# CITY PLANNING COMMISSION

- APPLICATION:**
- A. Variance to locate two required parking spaces for a proposed office use off-site on an adjacent lot (6-A-10);
  - B. Variance to reduce the required parking space maneuvering area from 26' to 22' (6-C-1-a);
  - C. Variance to reduce the required parking lot tree shading requirement from 50% to 34% (6-D-19);
  - D. Variance to waive the required six-foot high solid masonry wall between residential and non-residential uses (3-7-b-1). (WITHDRAWN)

**LOCATION:** 1215 G Street

P87-075

# EXHIBIT A

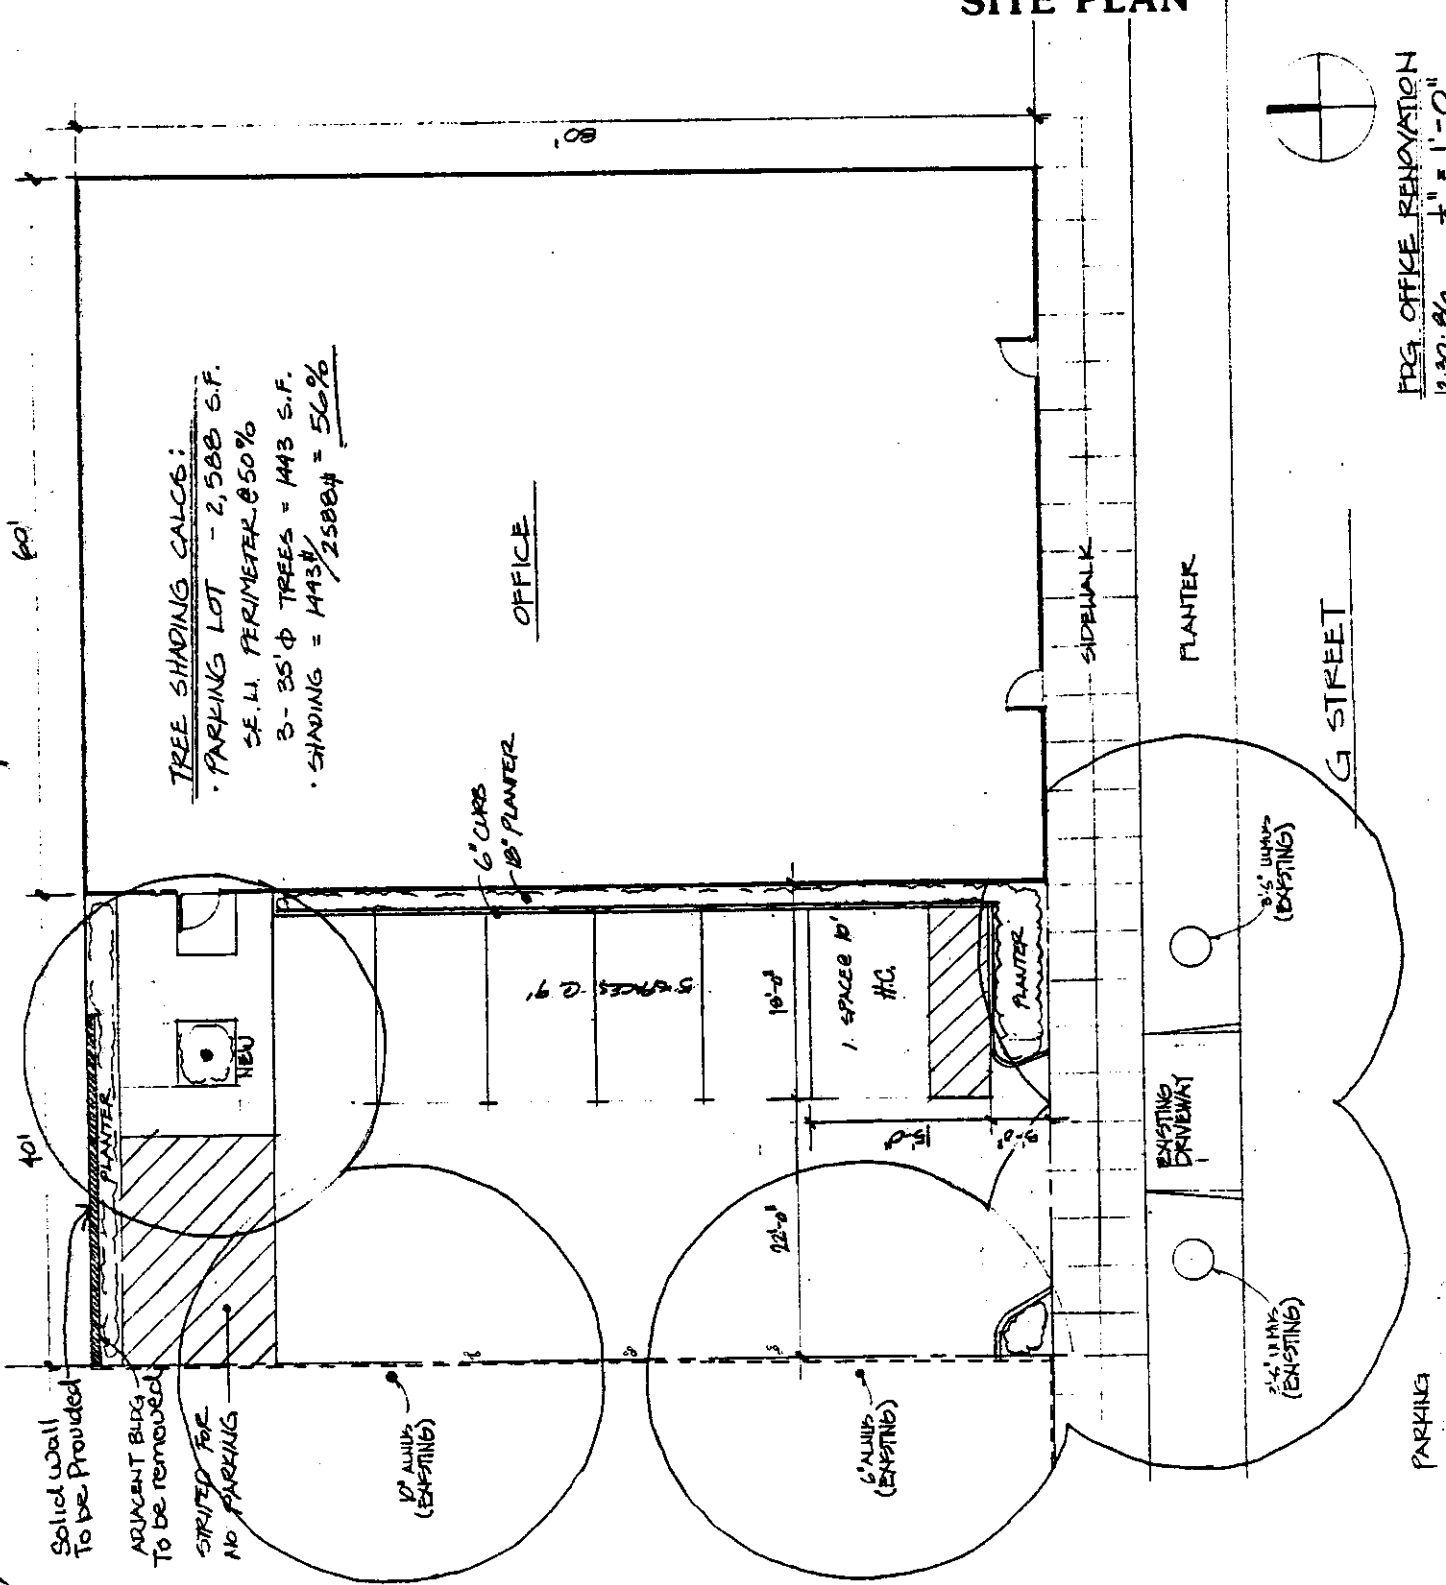
The proposed parking lot site is only 40 feet wide and a variance is requested to reduce the required maneuvering width to 22 feet. At staff suggestion the applicant has designed the parking spaces to be 9-feet wide to compensate for the lack of maneuvering depth. Planning and Building Division staff find that this site plan modification will compensate for the reduction in maneuvering area.

The applicant is also requesting a variance to reduce the 50 percent shading requirement. A new tree will be planted on the site which will produce 34 percent shading for the site. A second tree could be planted in the southern planter on the site which would achieve the 50 percent shading requirement. A tree planted in this area, however, would grow misshapen and probably die due to the fact it would be planted under the existing elms. Planting a new tree in this area may also be harmful to the root system of the existing elms. The shade produced by existing off-site trees and the proposed new tree will exceed the 50 percent shading required for the site. Staff, therefore, does not object to the variance request to reduce the shading requirement to 34 percent.

The project has been reviewed by the City Traffic Engineering Division. As noted above, a variance will be required to utilize an existing driveway of substandard width. Traffic Engineering recommends that the planter at the southwest corner of the site be extended to a length of approximately 12 feet from the western property line and if either of the City's elm trees are removed in the future that the driveway be redesigned to meet the requirements of the Traffic Engineering Division.

1. Revised landscape, shading and irrigation plans shall be submitted for staff review and approval prior to issuance of building permits. Screening shrubs shall be planted in the southern planter and the planting area for the tree on the northern portion of the site shall be wide enough to meet the 34 percent shading requirement.
2. The applicant shall obtain a variance from the City Council to use the existing driveway for the proposed parking lot.
3. The design and materials of the required six-foot high solid wall along the north property line shall be subject to Planning Director review and approval prior to issuance of building permits.
4. The applicant shall enter into an agreement with the City indicating that the parking lot on the western lot provides the required parking for the office

5. The project is subject to the review and approval of City Design Review/ Preservation Board staff.
6. If either of the City's two elm trees are removed, the site plan shall be redesigned to meet the driveway requirements of the City Traffic Engineering Division and an additional tree for shading purposes shall be planted on the subject site.
